P-5071
S1307
26368

SYMBOL OF QUALITY AN ISO 9001 COMPANY	JINDAL ALUMINIUM LTD. BANGALORE-560073 (INDIA)	NAME	DATE
		DRAWN	J.P.KAUSHIK
1. ALL DIMENSIONS ARE IN mm. 2. ROUND OFF ALL SHARP CORNERS WITH 0.40 mm. 3. TOLERANCES WILL BE AS PER IS:3965-1981 UNLESS OTHERWISE SPECIFIED		CHECKED	
		APPROVED	
PARTY'S NAME SOLIDUS HITECH, BANGALORE		SCALE	1:1
		AREA mm ²	1246.653
PARTY'S DRAWING No. OM-1403		PERIMETER mm.	786.987
		WEIGHT kg/m	3.366
ALLOY & TEMPER HE9 WP		DRAWING No.	SECTION No.
		P-5071	-
DESCRIPTION HEAT SINK		S1307	S1307
		26368	26368(ISSUE-3)

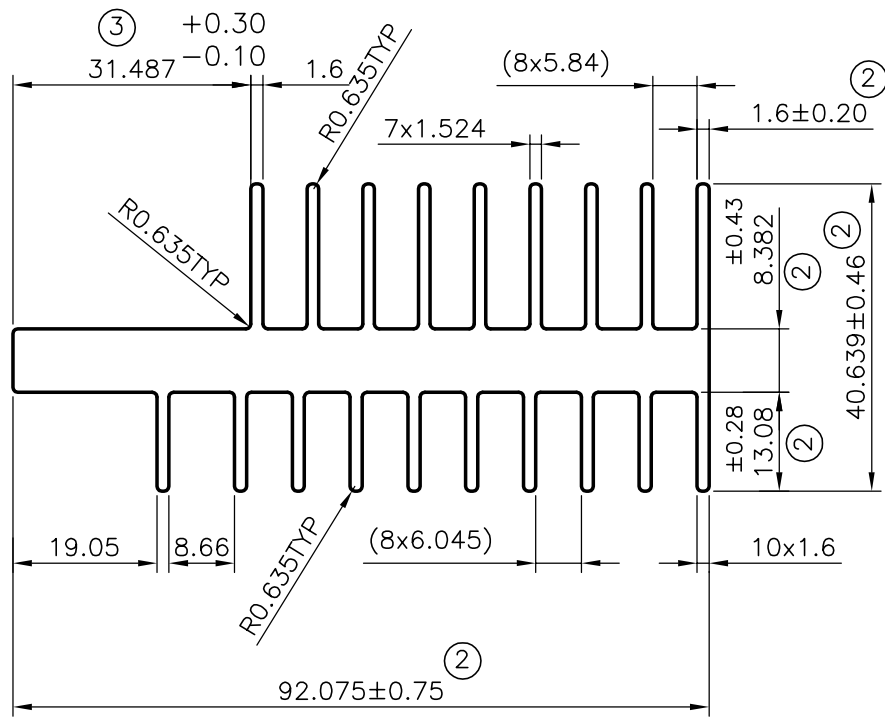
ISSUE-2
 31.487±0.25 DIMENSION ADDED &
 TOLERANCES ADDED (5 DIMENSIONS)

ISSUE-3
 TOLERANCE CHANGED 31.487±0.25 TO 31.487 -0.10
